Approved Drainage Proposal and
Approval Letter for Compliance with Approval Condition (c)
of last application No. A/NE-TKL/721

Drainage Design for the site at DD84

Proposed Temporary Warehouse for Storage of Construction Materials and Electronic Products for a Period of 3 Years in "Agriculture" Zone, Lots 4 S.A (Part), 4 S.B (Part), 4 S.C (Part) and 6 S.B in D.D. 84 and Adjoining Government Land, Ping Che (Compliance with Approval Condition (c) for Planning Application No. A/NE-TKL/721)

**Proposed Temporary Warehouse for Storage of Construction Materials and Electronic Products for a Period of 3 Years in “Agriculture” Zone, Lots 4 S.A (Part), 4 S.B (Part), 4 S.C (Part) and 6 S.B in D.D. 84 and Adjoining Government Land, Ping Che
(Compliance with Approval Condition (d) for Planning Application No. A/NE-TKL/721)**

Topographic Survey & Catchment Areas

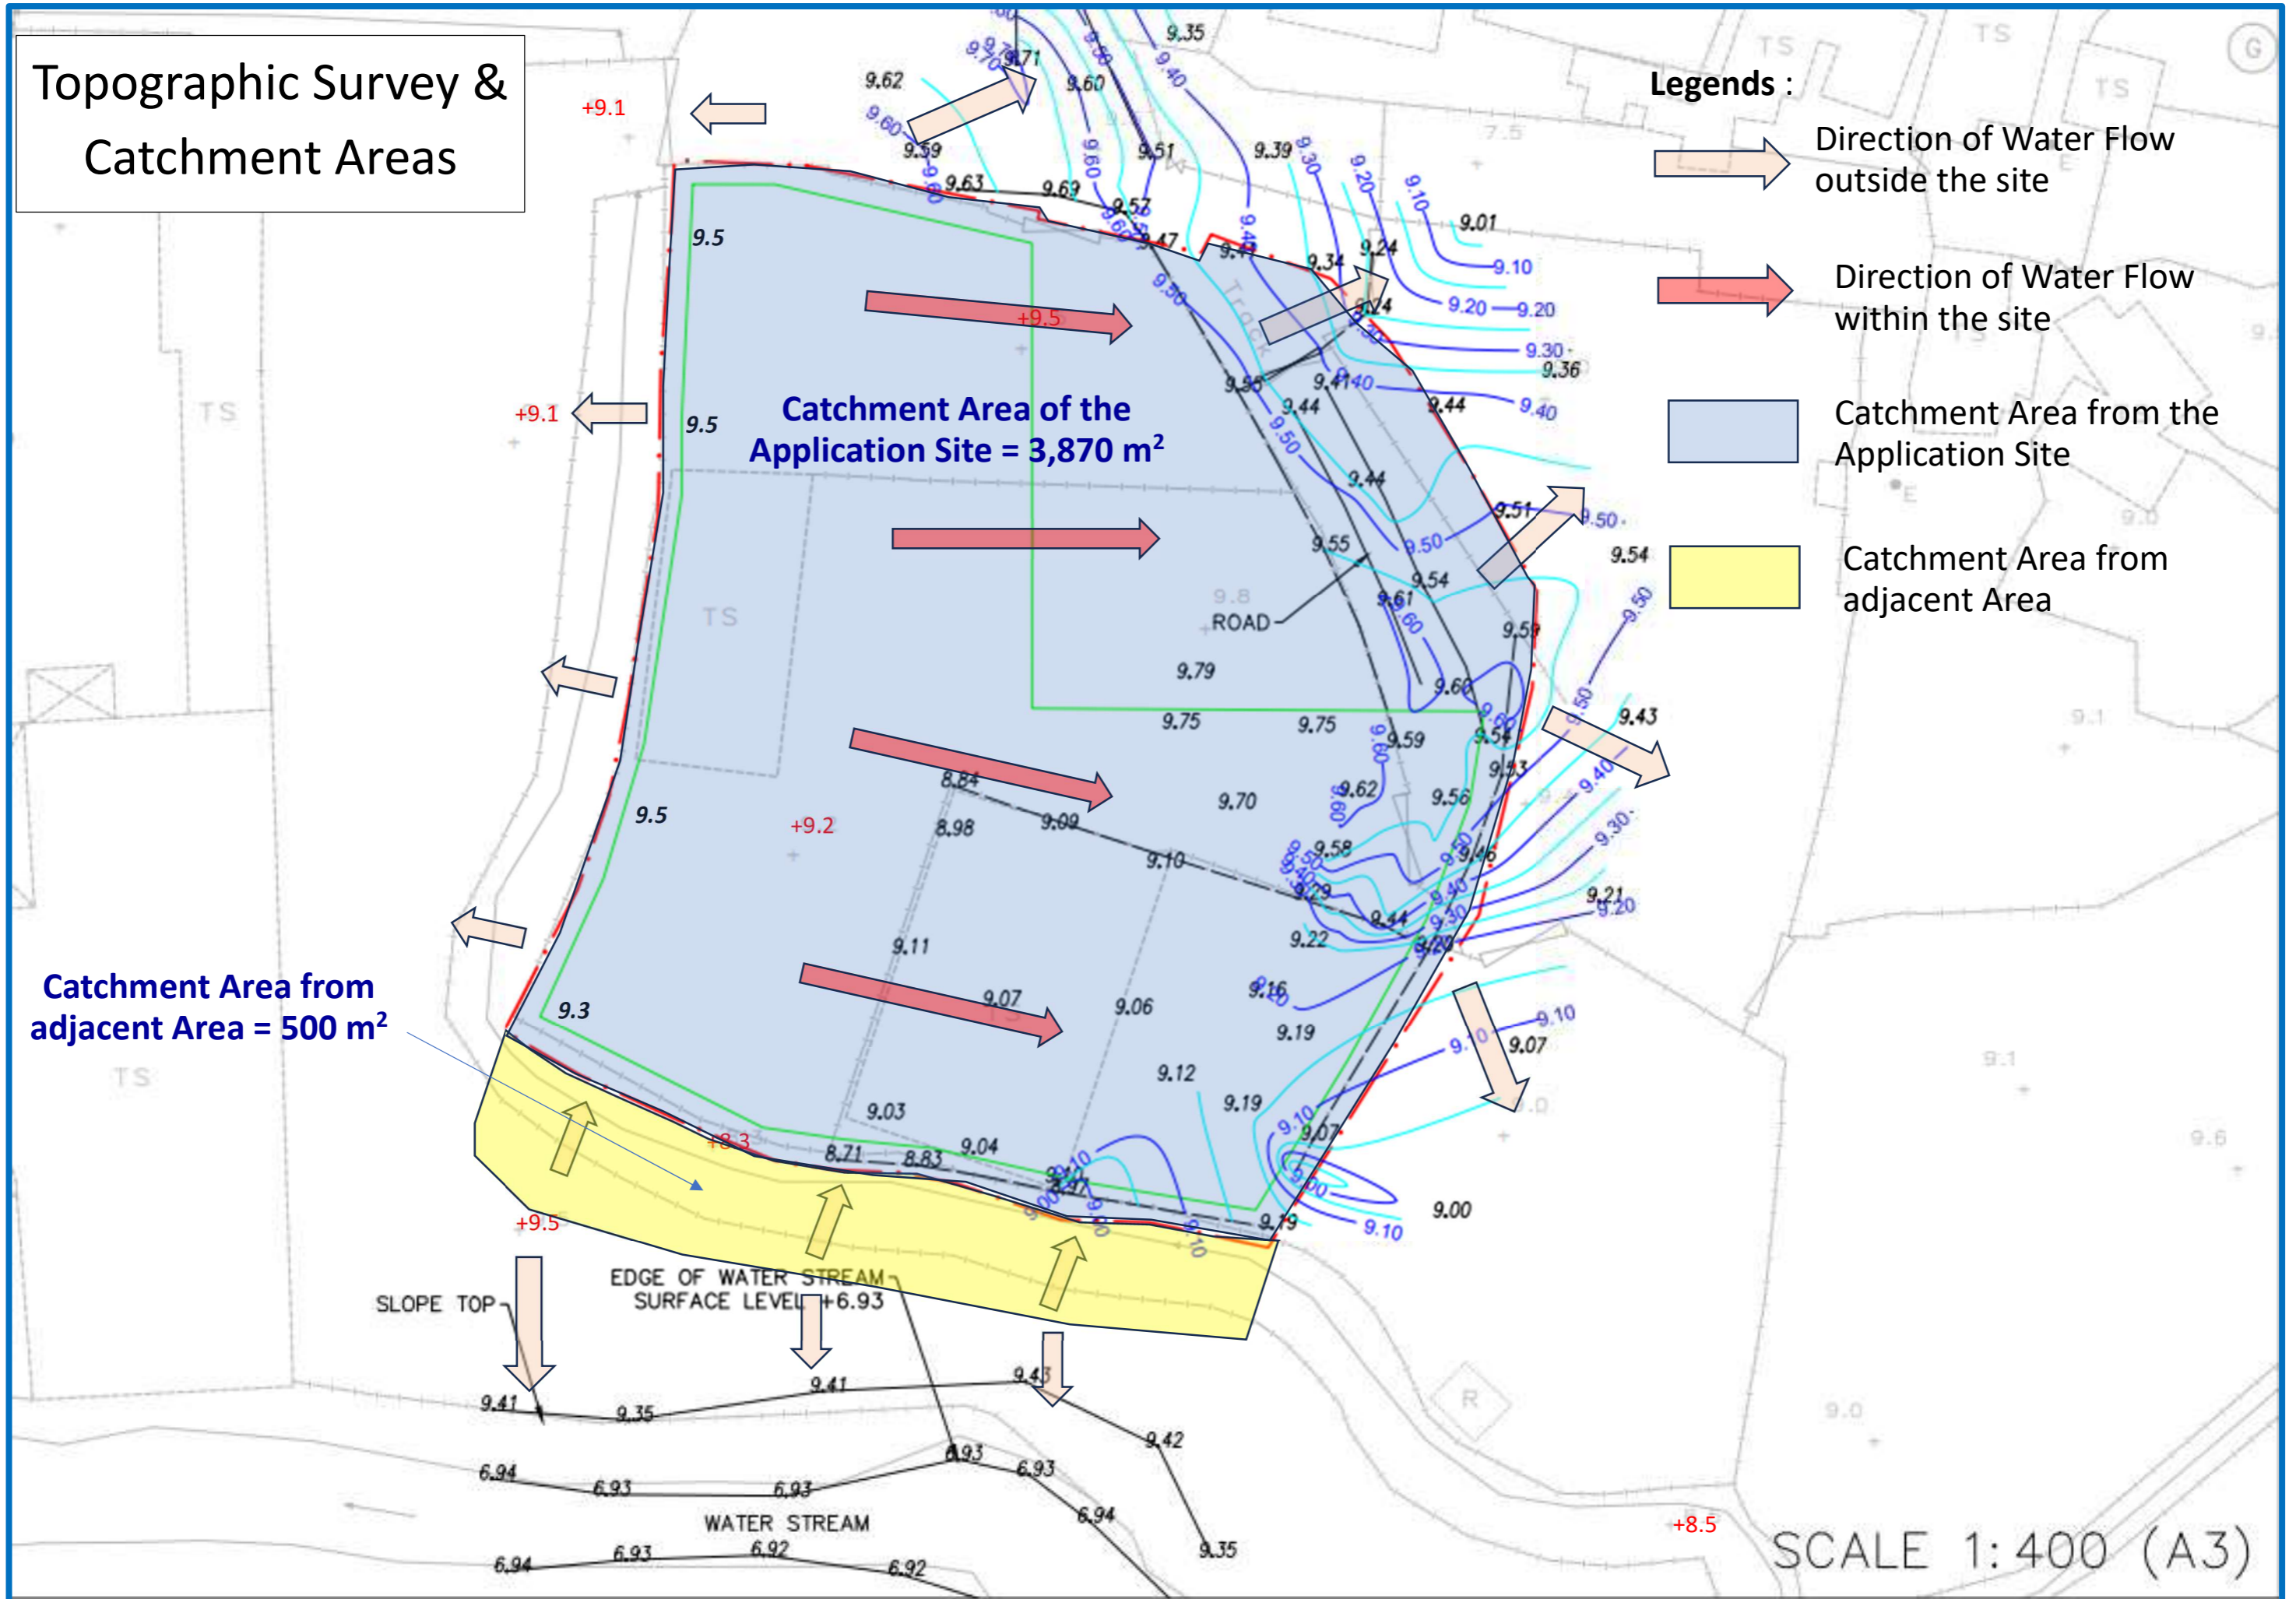
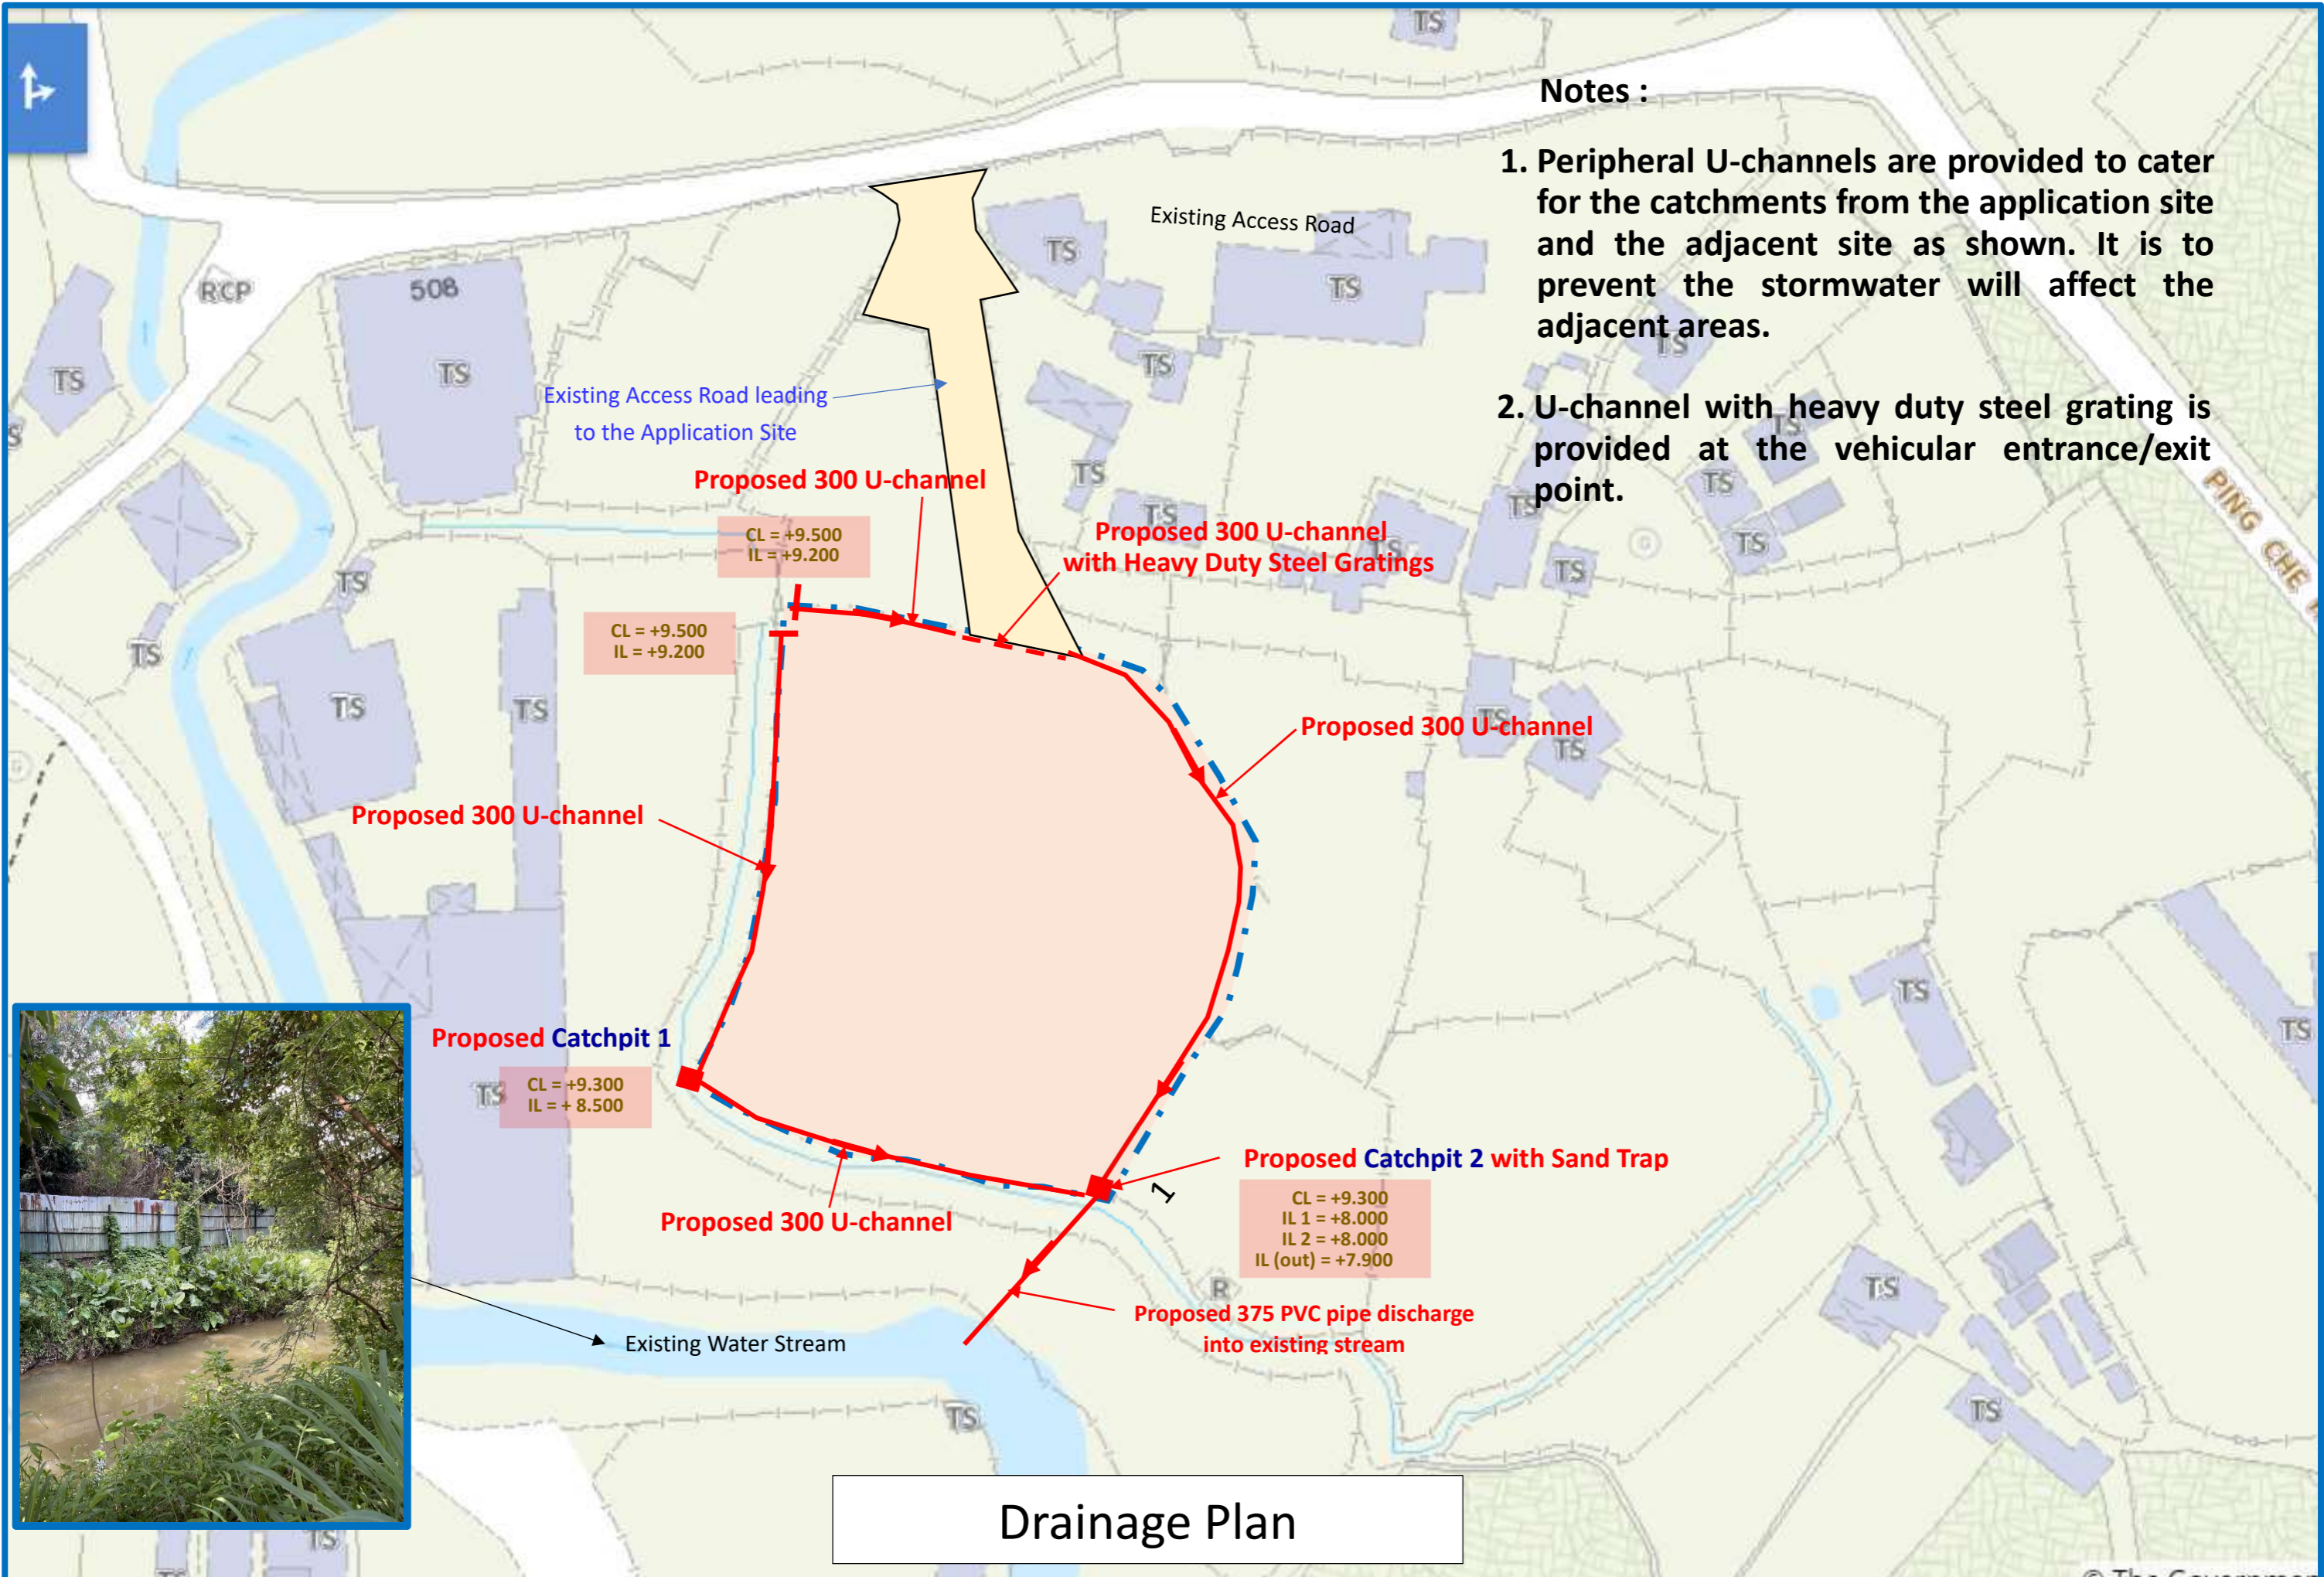
- (a) The “existing water stream” to which the applicant proposed to discharge the storm water from the subject site is **not** maintained by this office. Consent from the owner/maintenance party, current users and DO/N should be sought for the proposed drainage connection. Moreover, regular maintenance should be carried out by the applicant to avoid blockage of drain.
